MANDATORY SERVICE BULLETIN

NO. MSB-42-058

I.5 Subject

WI-MSB-42-058

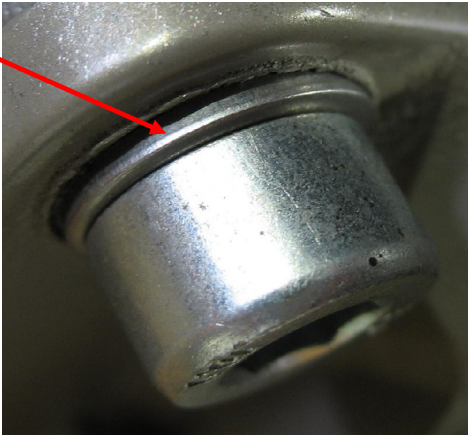
Check the installed attachment of the right rear engine support bracket for the type of used washers. The picture shows only the two rear bolts.

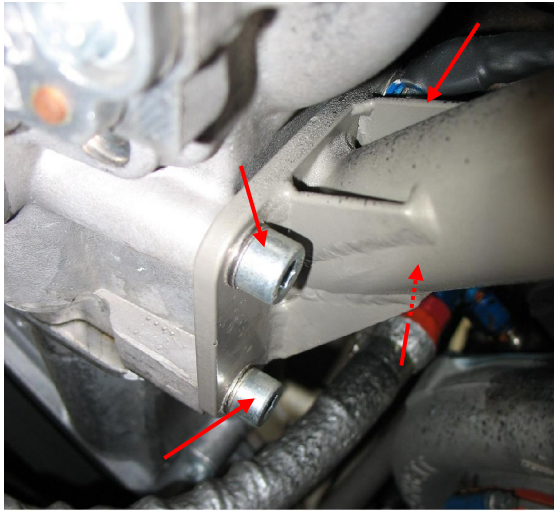
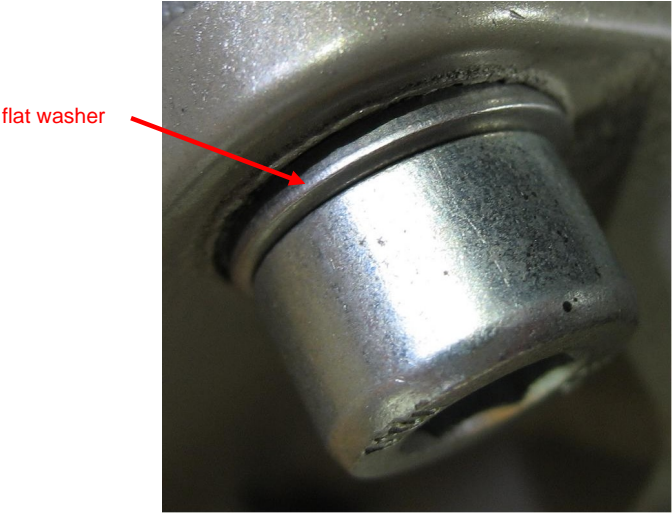
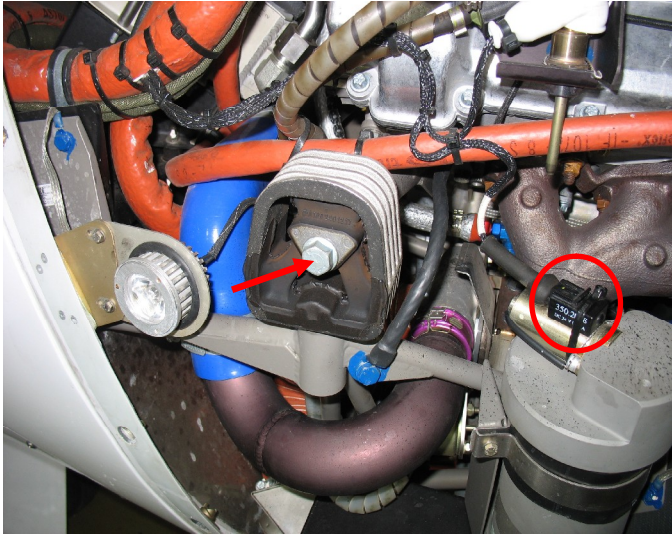
If for the attachment of the right rear engine support bracket Wedge Locking Washers are used as it is shown in the pictures there is no further action required, proceed with item 10 of this section.

Note: In connection with Wedge Locking Washers two different kinds of screws are used for the attachment of the engine support bracket, hexagon head screws or hexagon socket screws.

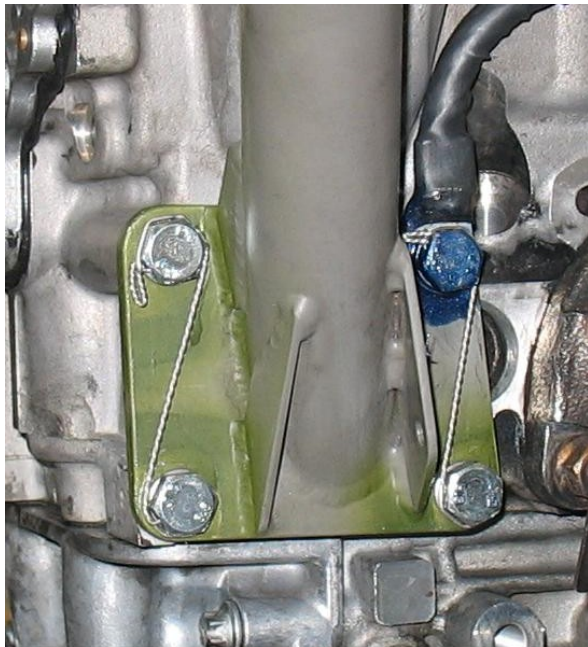
Remove the powder coating from the engine support bracket in the contact area of the four bolts and the cylinder head (e.g. with a sharp knife and sandpaper or metal brush) and roughen the blank steel surface. Clean the blank surfaces and degrease them with clean solvent. Use tape to cover the blank area around the upper forward hole of the engine support bracket where the bonding cable is mounted.

Use TEMPO Aviation Zinc Chromate Primer (or equivalent) to cover the area where the powder coating was removed. Clean the blank surface that was protected by the tape with clean solvent. Let the Primer dry as it is advised by its manufacturer.
